SUBJECT: THREE MILE ISLAND NUCLEAR STATION, UNIT 1 - STAFF ASSESSMENT OF INFORMATION PROVIDED PURSUANT TO TITLE 10 OF THE *CODE OF FEDERAL REGULATIONS* PART 50, SECTION 50.54(f), SEISMIC HAZARD REEVALUATIONS FOR RECOMMENDATION 2.1 OF THE NEAR-TERM TASK FORCE REVIEW OF INSIGHTS FROM THE FUKUSHIMA DAI-ICHI ACCIDENT (TAC NO. MF3905)

STAFF ASSESSMENT BY THE OFFICE OF NUCLEAR REACTOR REGULATION

RELATED TO SEISMIC HAZARD AND SCREENING REPORT

THREE MILE ISLAND NUCLEAR STATION, UNIT 1

Figure 3.3- 1 Plot of Staff's and Licensee's Base Case Shear-Wave Velocity Profiles for the TMI Site

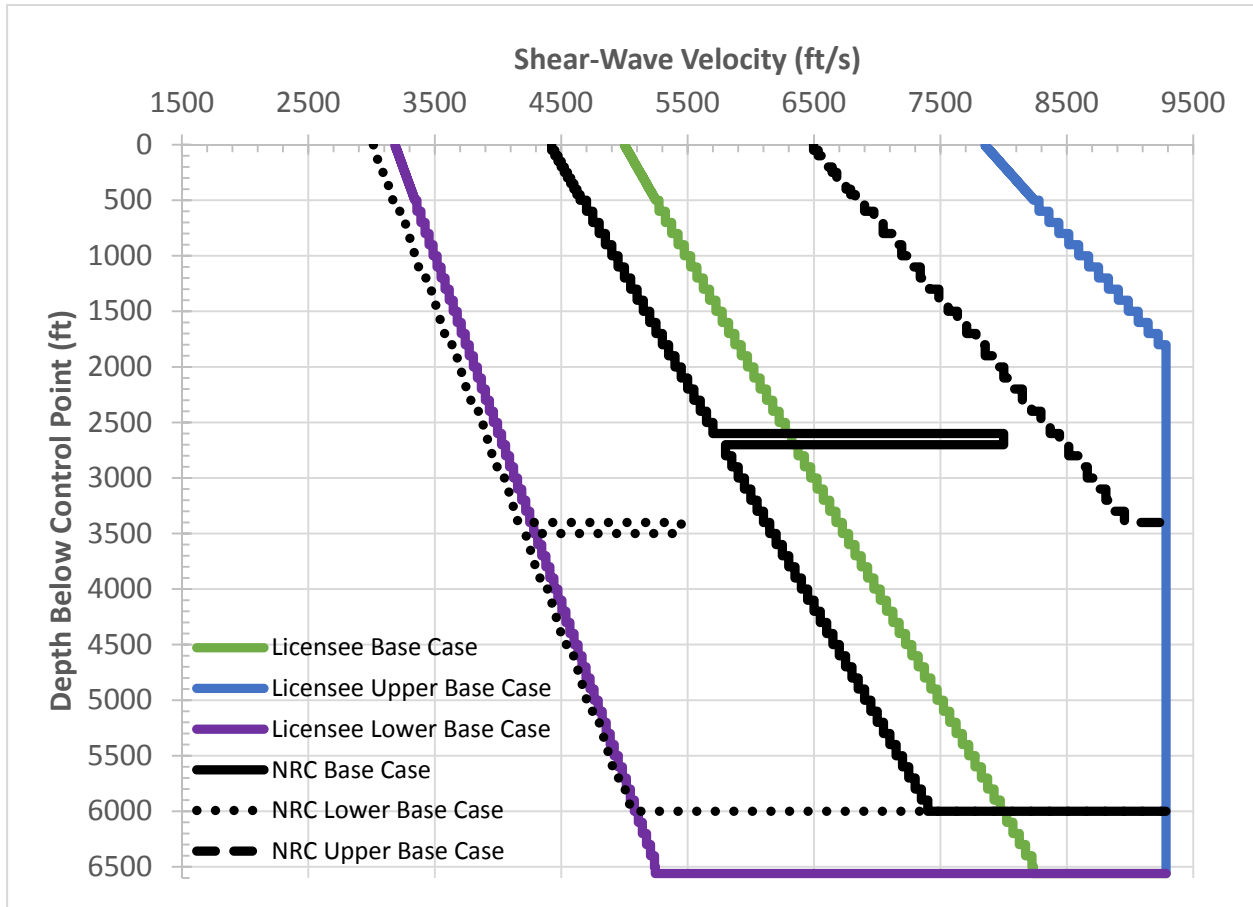
To characterize the subsurface geology, the licensee developed three site base case profiles. The middle, or best estimate, profile was developed using a shallow velocity of 5,000 fps (1,524 m/s) reflecting a Poisson ratio of 0.35 and assumed a shear wave velocity gradient of 0.5 m/s/m. Upper and lower base case profiles were developed using a scale factor of 1.57 to reflect a natural log standard deviation of 0.35. Figure 3.3-1 of this assessment shows the licensee's three shear-wave velocity base case profiles.

Following guidance provided in the SPID for sites with less subsurface information, the staff independently determined best-estimate and upper and lower base case shear-wave velocity profiles. The NRC staff based its best-estimate velocity profile on information in the TMI UFSAR and guidance provided in the SPID. The staff modeled the velocity at the top of rock with a shear-wave velocity of 4,425 fps [1,349 m/s]. This velocity corresponds to a Poisson's ratio of 0.37, given an average compressional wave velocity of 9,700 fps [2,957 m/s], which is based on seismic refraction profiles in the TMI UFSAR. Consistent with guidance in the SPID, the NRC staff used a velocity gradient of 0.5 fps/ft to model the increase in shear-wave velocity with depth. Based on geologic maps of the region surrounding the TMI site (Bert, et al., 1980; Miles, et al., 2001), the NRC staff included a layer of diabase in the site profiles. Because the depth of this layer beneath the TMI site is uncertain, the NRC staff included it at a different depth in each base case. The NRC staff used a natural log standard deviation of 0.3 to calculate upper and lower base case velocity profiles. Figure 3.3-1 of this assessment shows a comparison of the three profiles developed by the licensee with those developed by the staff. Overall, the profiles developed by the NRC staff are weighted towards slightly lower velocities than those assumed by the licensee. The NRC staff randomized the depth to reference rock by ± 10 percent to allow for additional uncertainty.

Figure 3.3- 2 Plot Comparing the Staff's and the License's Median Amplification Functions and Uncertainties for Two Input Loading Levels for the TMI Site

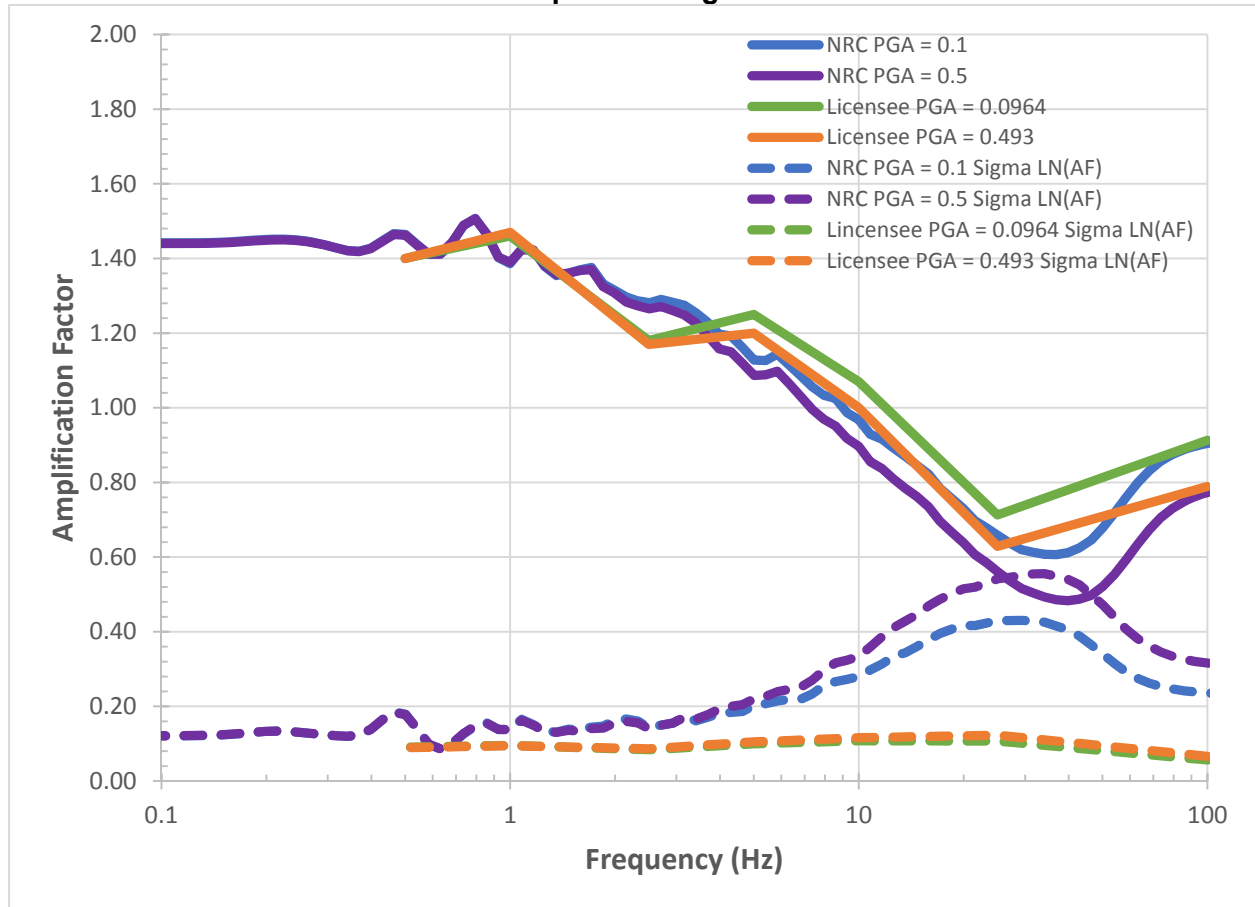
Figure 3.3-2 of this assessment shows a comparison of the NRC staff's and the licensee's median site amplification functions and uncertainties (± 1 standard deviation) for 2 of the 11 input loading levels. The amplification functions are highest at frequencies of less than 1 Hz and decrease with increasing frequency. Amplification functions calculated by the NRC staff and the licensee are similar, however uncertainties are higher for the staff's profiles. This is due to the greater epistemic uncertainty in the staff's kappa values and damping parameters.

Figure 3.3-3 Plot Comparing the Staff's and the Licensee's Mean Control Point Hazard Curves at a Variety of Frequencies for the TMI Site

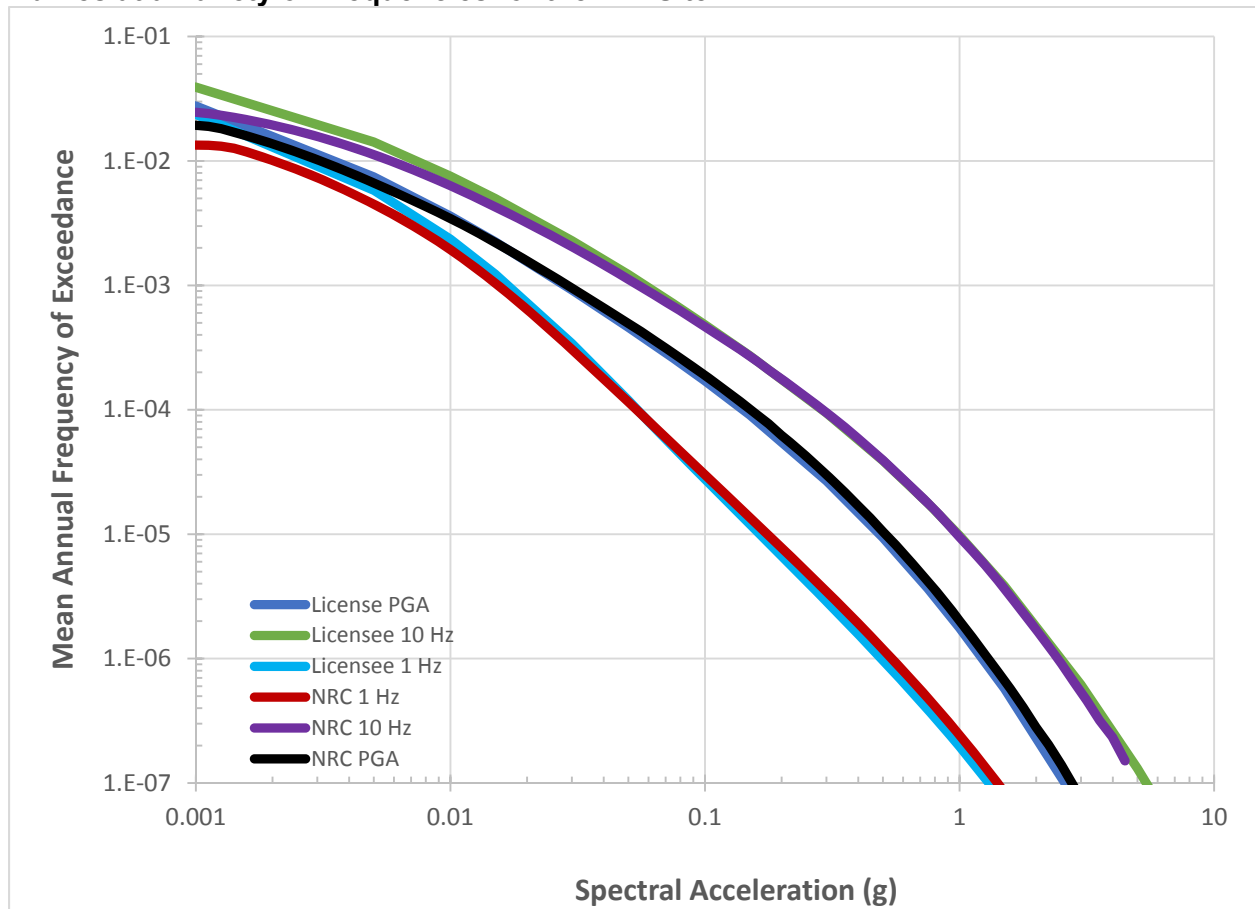
The licensee's approach to modeling the subsurface rock properties and their uncertainty results in similar site amplification factors to those produced by the NRC staff. As shown in Figure 3.3-3 of this assessment, minor differences in site amplification and uncertainty has a very minor impact on the control point seismic hazard curves and the resulting GMRS, discussed below. Appendix B of the SPID provides guidance for performing site response

Figure 3.4-1 Comparison of the Staff's GMRS with Licensee's GMRS and the SSE for the TMI Site

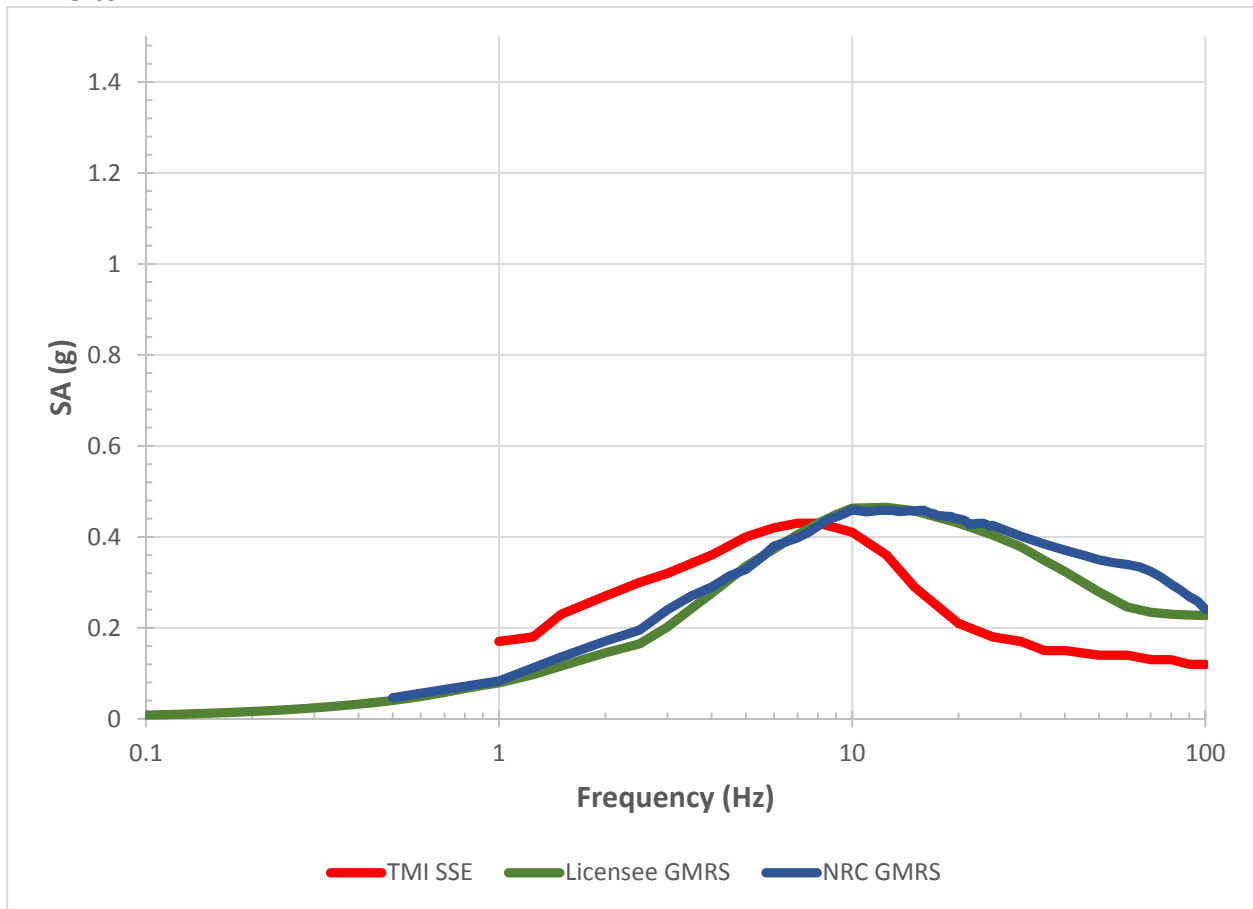
The NRC staff independently calculated the 10^{-4} and 10^{-5} UHRs using the results of its confirmatory PSHA and site response analyses, as described in Sections 3.2 and 3.3 of this assessment, respectively. Figure 3.4-1 of this assessment shows a comparison of the GMRS determined by the licensee to that determined by the NRC staff.

As shown in Figure 3.4-1, the licensee's and NRC staff's GMRS shape are very similar. The licensee's GMRS is somewhat lower than the NRC staff's confirmatory analysis at varying frequencies, particularly above 25 Hz. As described above in Section 3.3, the NRC staff concludes that these minor differences over this frequency range are primarily due to the differences in the site response analyses performed by the licensee and NRC staff.

In reaching this determination, the NRC staff confirms the licensee's conclusion that the licensee's GMRS for the TMI site exceeds the SSE over the frequency range of approximately 8 to 100 Hz. As such, a seismic risk evaluation, SFP evaluation, and high-frequency confirmation are merited. The licensee indicated that the high frequency confirmation can be performed as part of its seismic risk evaluation. The NRC review and acceptance of the licensee's seismic risk evaluation, high frequency confirmation, interim ESEP evaluation, and SFP evaluation (i.e., Items (4), (6), (8), and (9)) for TMI will complete Seismic Hazard Evaluation identified in Enclosure 1 of the 50.54(f) letter.
